DEVELOPMENT REVIEW BOARD REPORT

Primrose at Windgate Crossing

25-DR-2016

Request: Request approval of the site plan, landscape plan, and building elevations for a new commercial building for child day care, with approximately 11,600 square feet of building area on an approximately 0.83-acre pad site within the 7.8-acre Windgate Crossing shopping center.

SHEET TITLE
PRELIM.
EXT. ELEV'S.

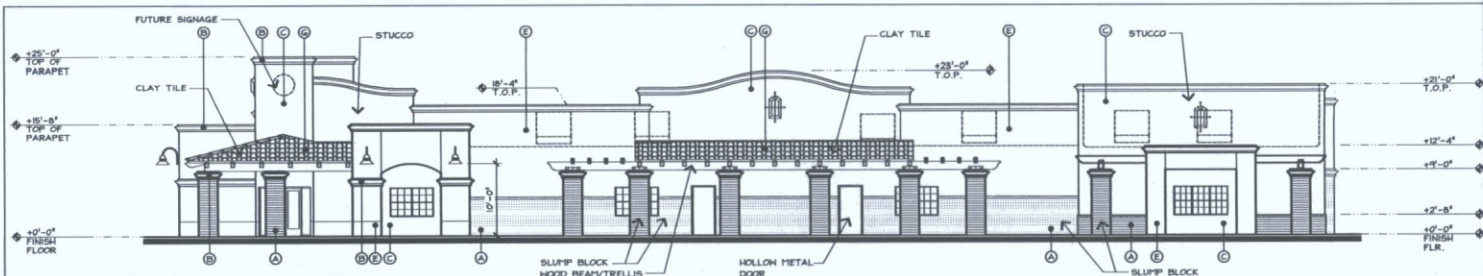
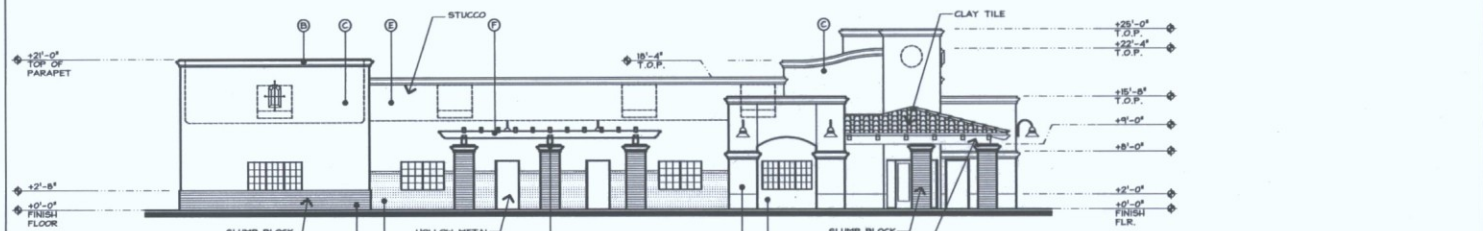
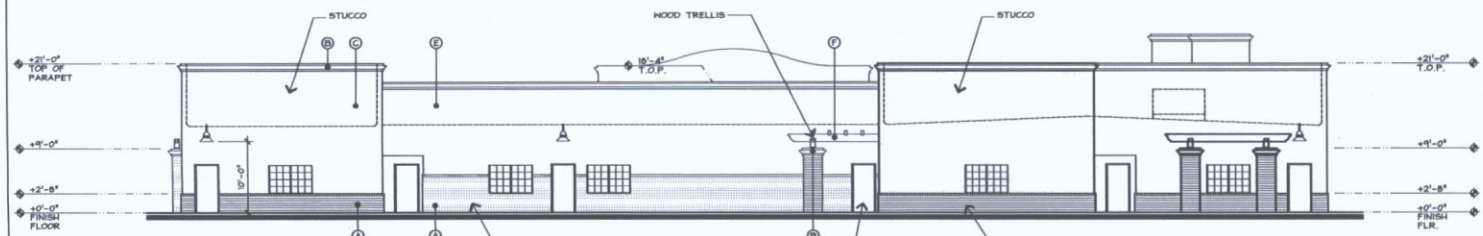
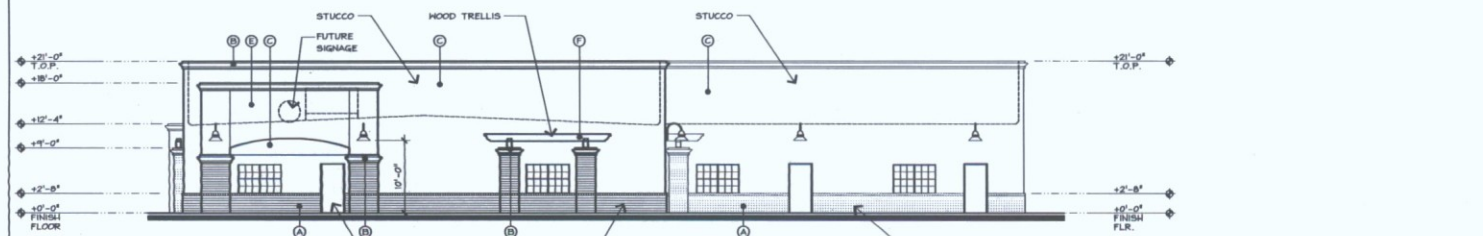
4. Several windows on the East, South, and West sides of the building appear to be unprotected from solar exposure, heat gain, and to minimize reflected heat. Please provide exterior shade devices for these windows and/or provide illustrations that demonstrate how proposed roof overhangs, canopies, and other exterior design elements provide shade for these windows. All shade devices should be designed so that the shade material has a density of 75%, or greater, in order to maximize the effectiveness of the shade devices.

7. At the time of final plans, the applicant shall identify the location of all building-mounted lighting fixtures on the building elevations.
8. If a roof access ladder is included with this building, it shall be located inside the building.

ATTACHMENT #8

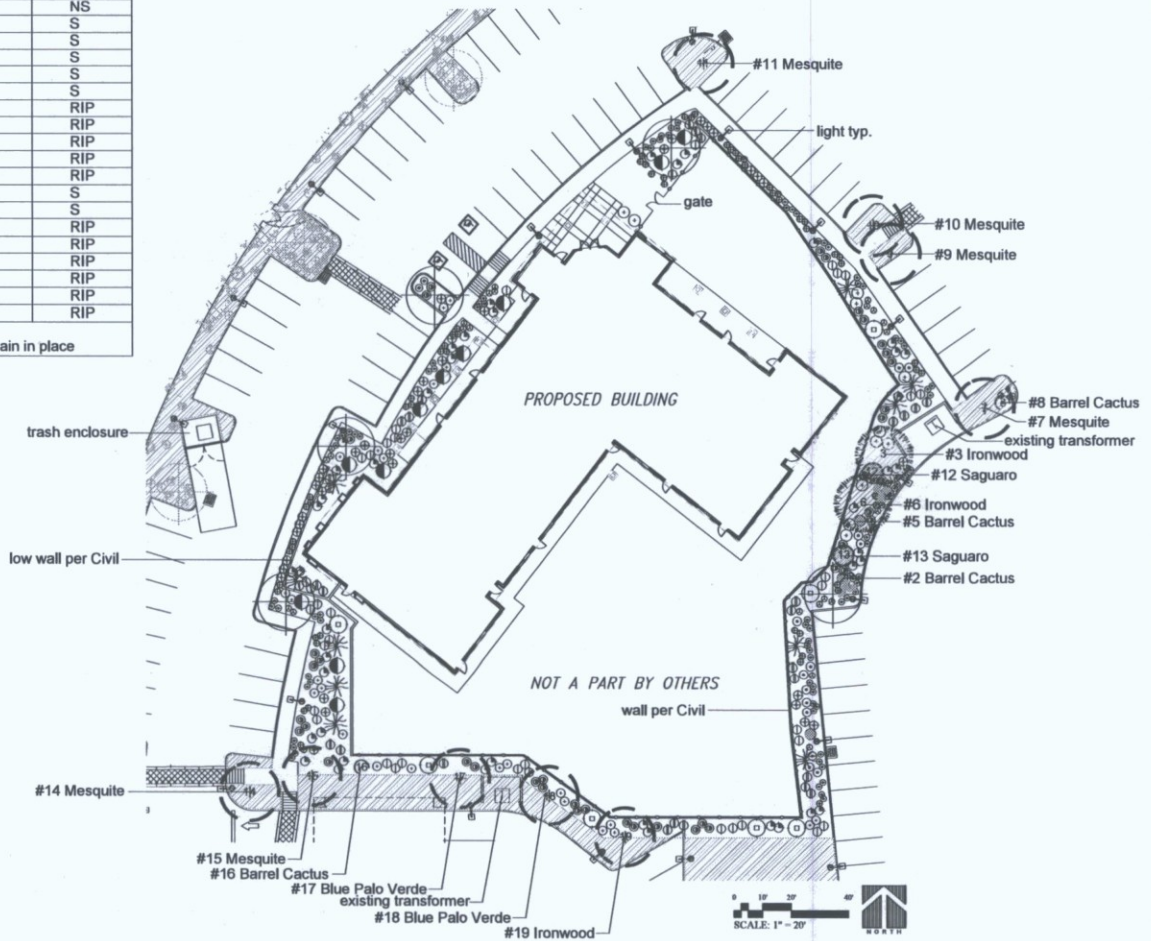
- 17. At time of final plans, the applicant shall revise the landscape palette to include only plants species selected from the Environmentally Sensitive Lands indigenous plant list.
- 18. Prior to the issuance of a building permit, the owner shall submit landscape improvement plans that demonstrate how the salvaged vegetation from the site will be incorporated into the design of the landscape improvements.
- 19. To avoid conflicts between the size of mature trees and light fixtures, please shift either the location of trees or the location of light fixtures so that there is at least twenty (20) feet between tree trunks and light fixtures, specifically the SA, SB, and SAEX light pole/fixtures.
